SCA100

Design Enhancement

JURATEK

Scania: 4 series

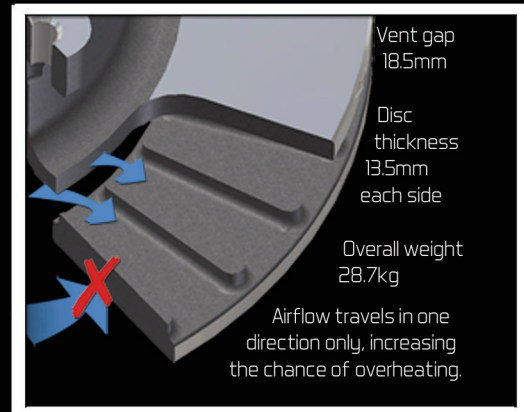
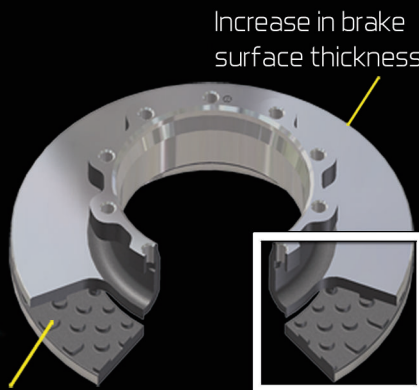
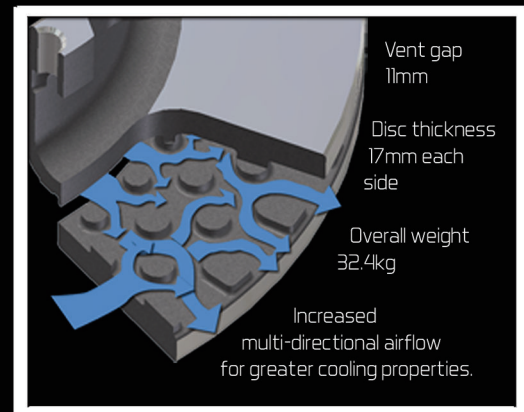
Wall type vent

Pillar vent design creating significantly more airflow.

✓ This new design improves the airflow and heat distribution due to the change in vent design and increased thickness of the braking surface, making the disc less likely to crack under severe conditions
